**PROJECT**  
**BEDMINSTER FARMS**  
 LOTS 12, 15, AND 21 BLOCK 39  
 BEDMINSTER TOWNSHIP  
 SOMERSET COUNTY  
 NEW JERSEY

Re: Bedminster Farms  
Preliminary and Final Major Subdivision Plans  
Block 39, Lots 12, 15, & 21, 1120 & 1320 Lamington Road  
Bedminster Township, Somerset County, New Jersey

On behalf of the applicant Bedminster Farms, the Subdivision Plans and associated documents have been revised to address comments in the Township Engineer and Township Planner's review memos.

In response to the Township Engineer's review memo dated June 5, 2020, we offer the following comments.

DATE	JANUARY 15, 2020	
SCALE	1" = 100'	JOB NO. 984-03
DRAWN	JAG	SHEET NO. 6 OF 14
CHKD.	MDD

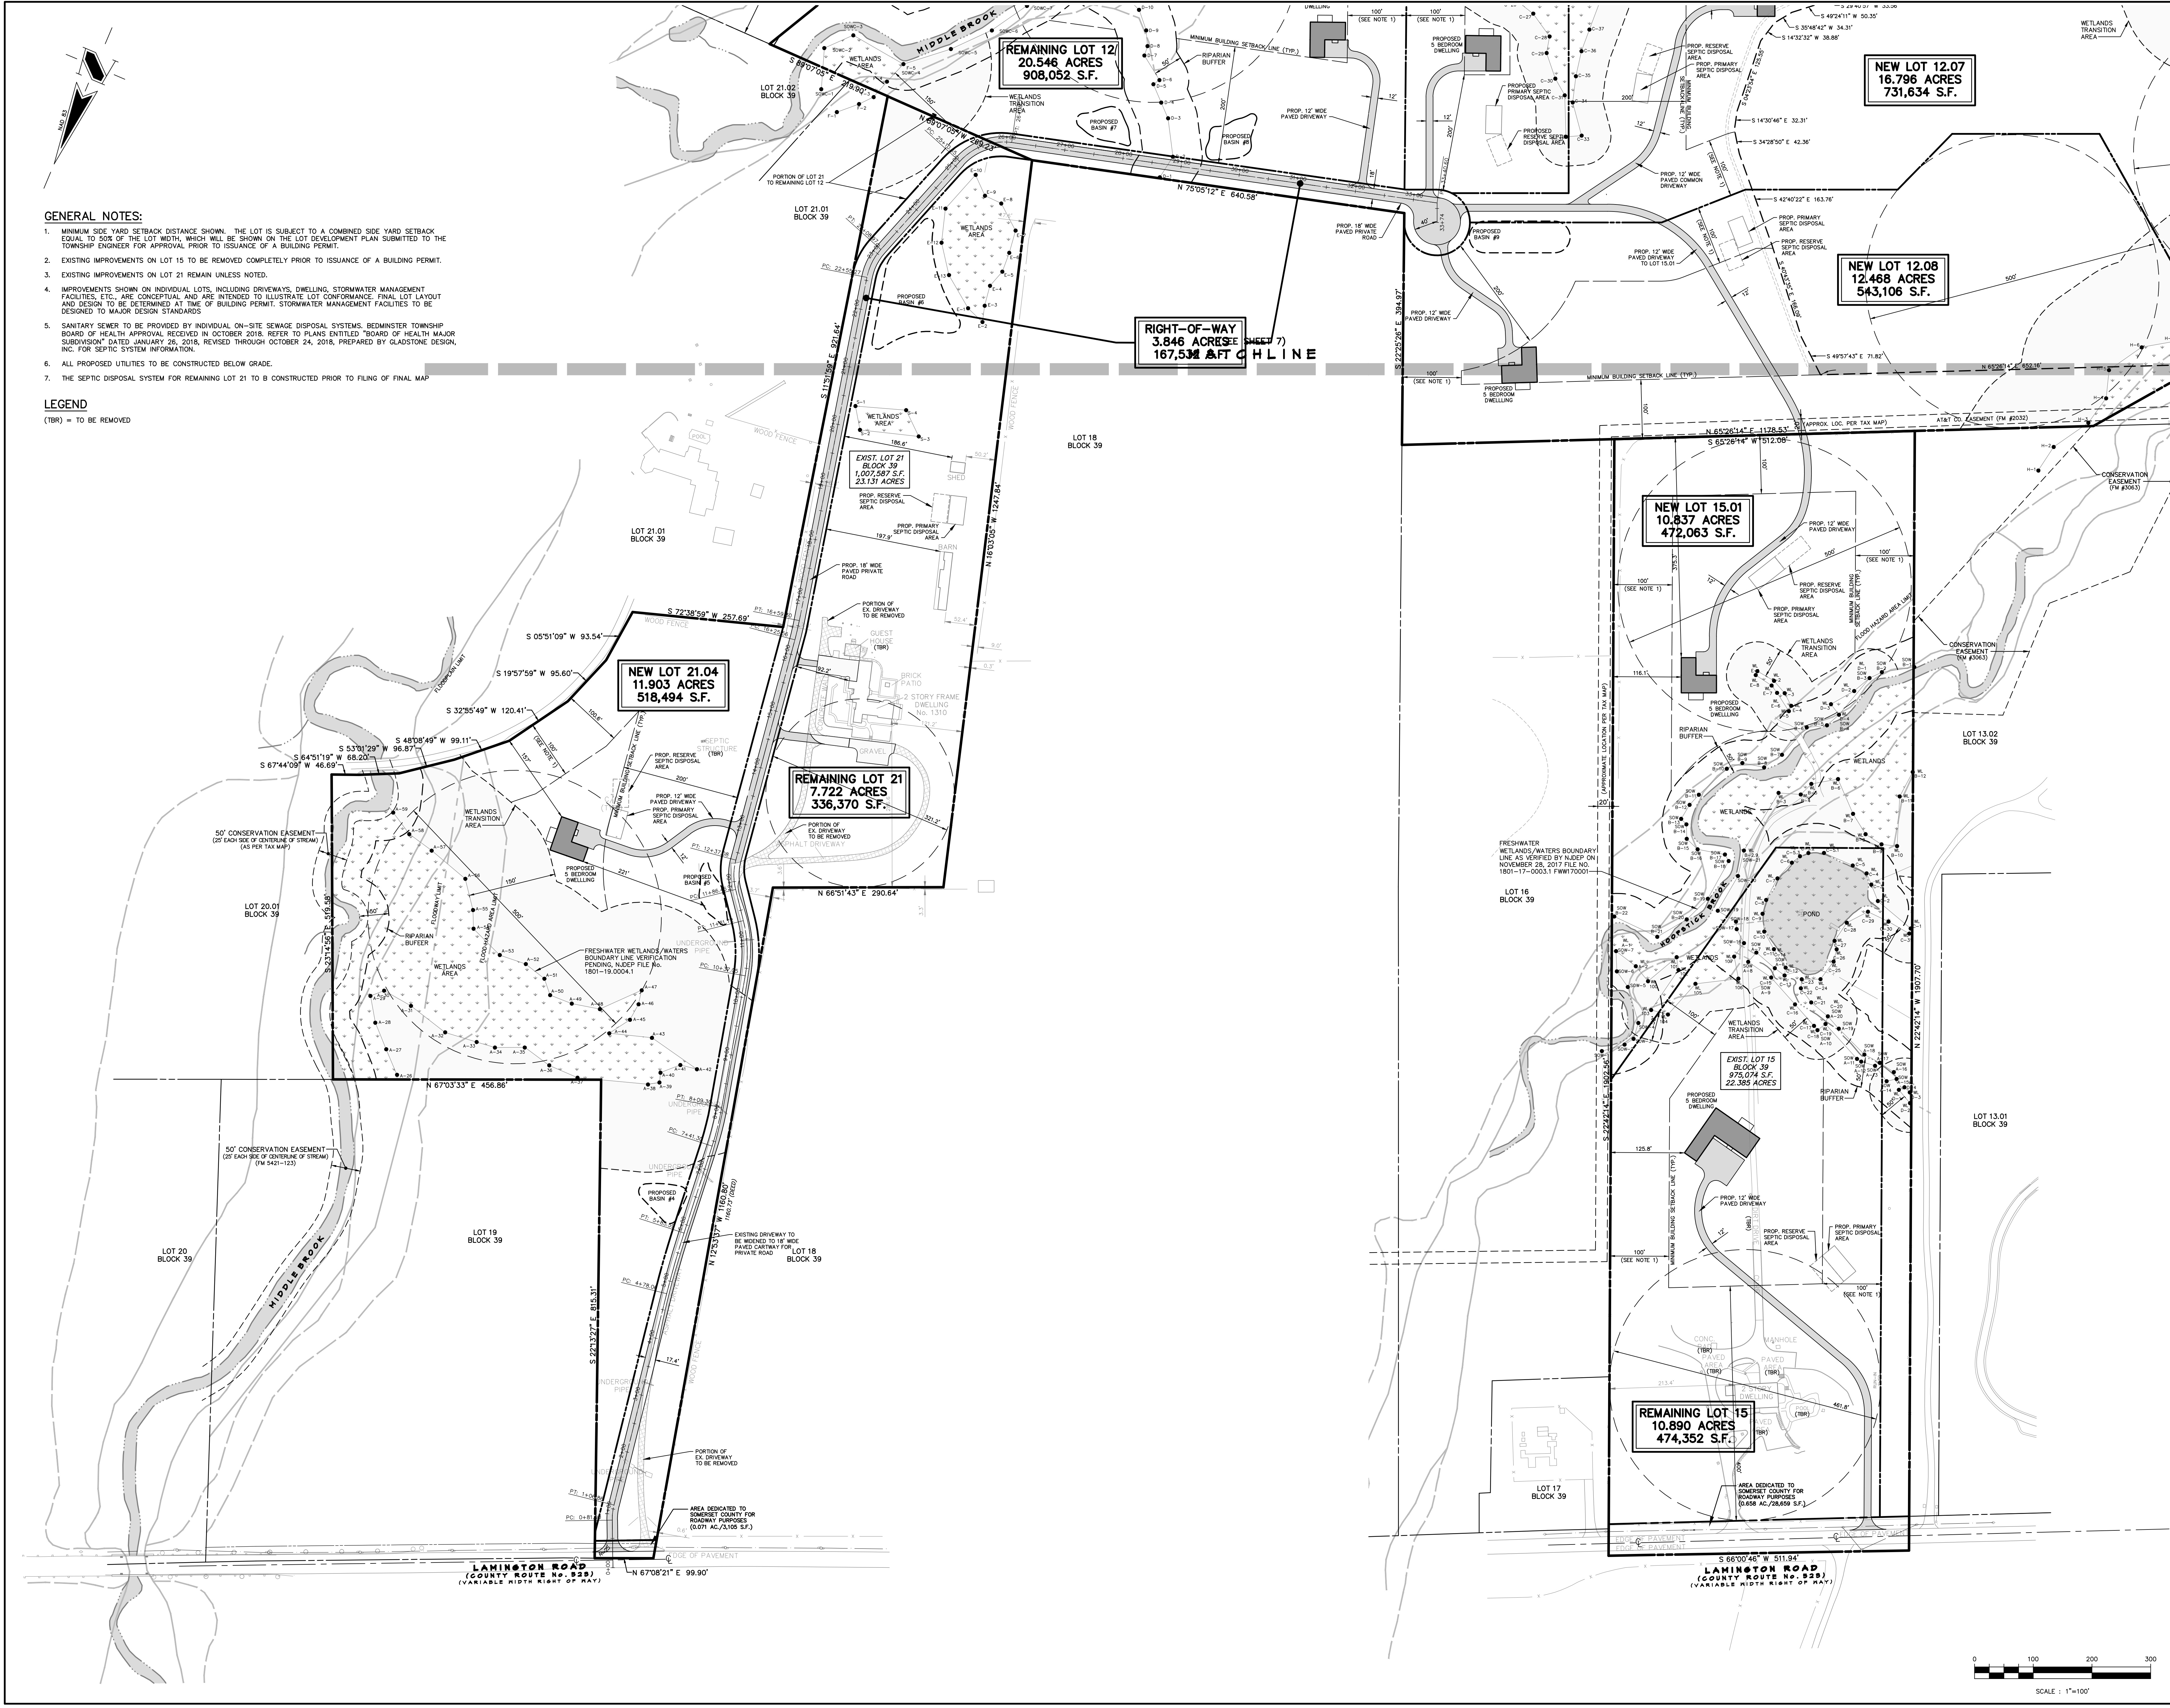
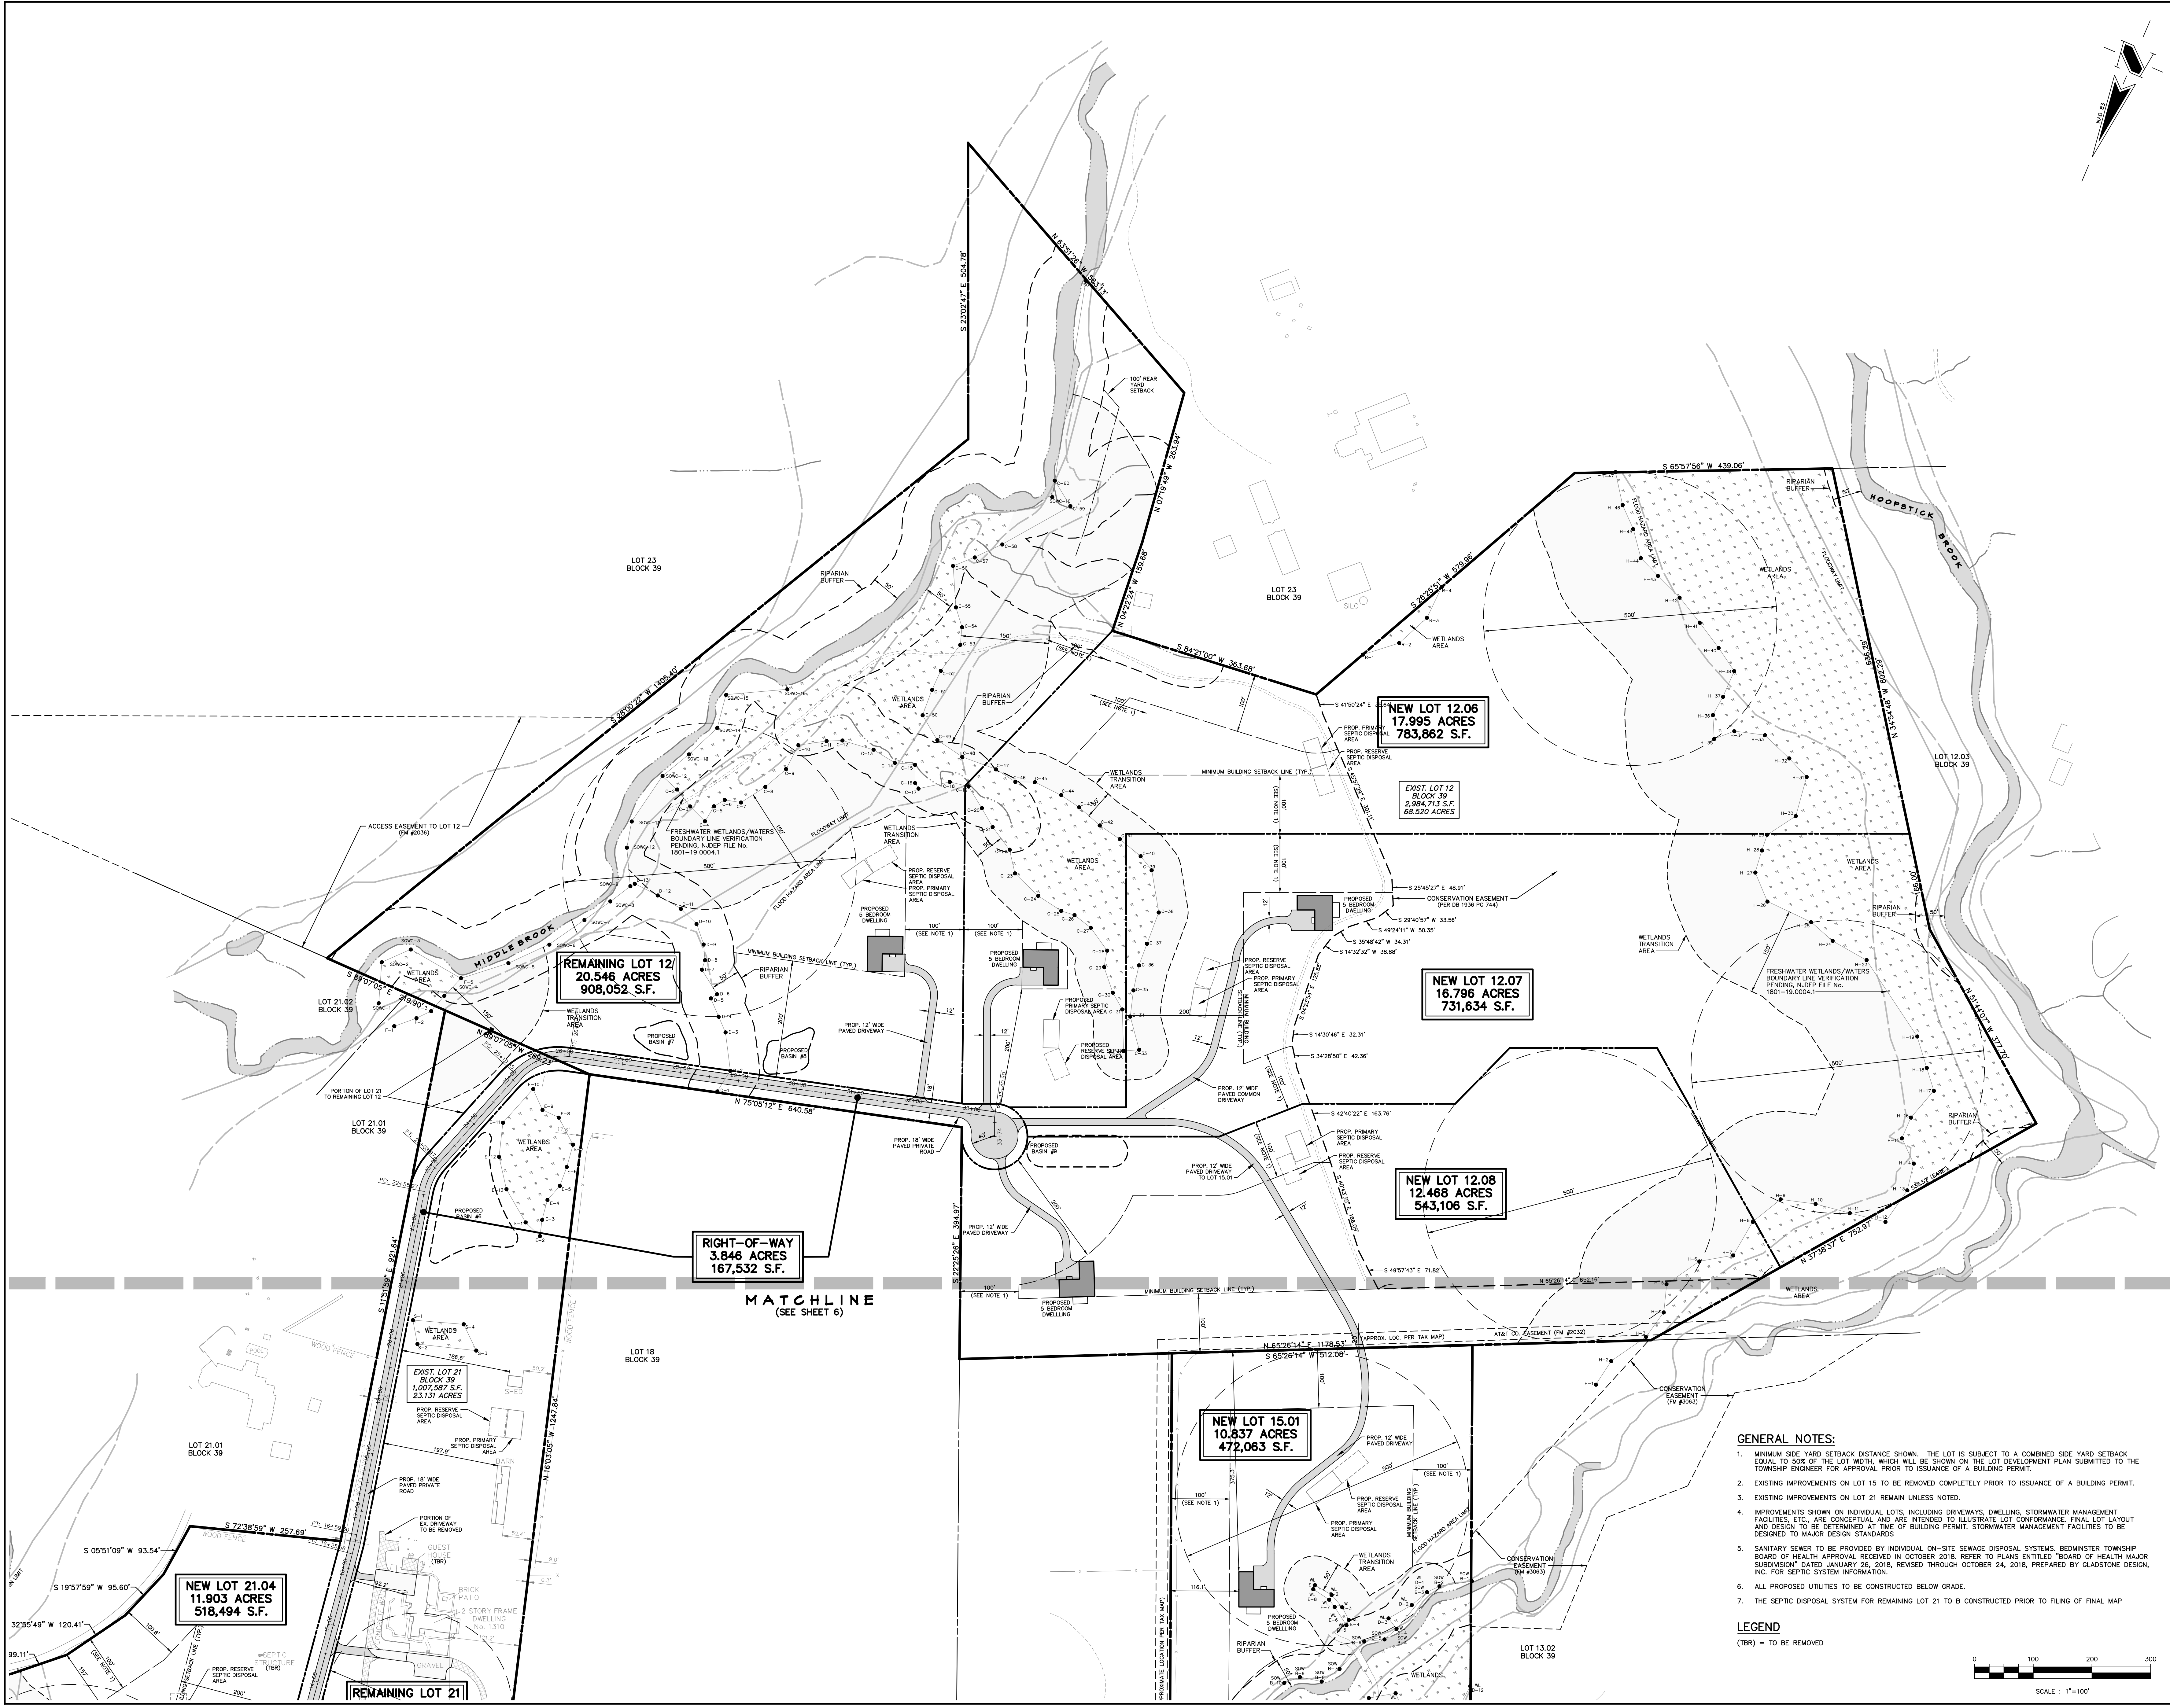
D. Sheets 6 and 7 – Site Dimension Plan (Preferred Layout)

- D. Sheets 6 and 7 – Site Dimension Plan (Preferred Layout)
  - 1. The plans have been revised to include the RSIS required 25-foot curb radii where the private road intersects with Lamington Road.
  - 2. Comment is a statement of fact; the applicant is aware the overall project is classified as a major development and as such each individual lot will comply with the major development stormwater standards at the time of Lot Development Plan.
  - 3. Comment is a statement of fact; the new septic disposal system for remaining Lot 21 will be constructed or bonded prior to the filing of the map.
  - 4. A note has been added to the plan stating all proposed utilities are to be underground.
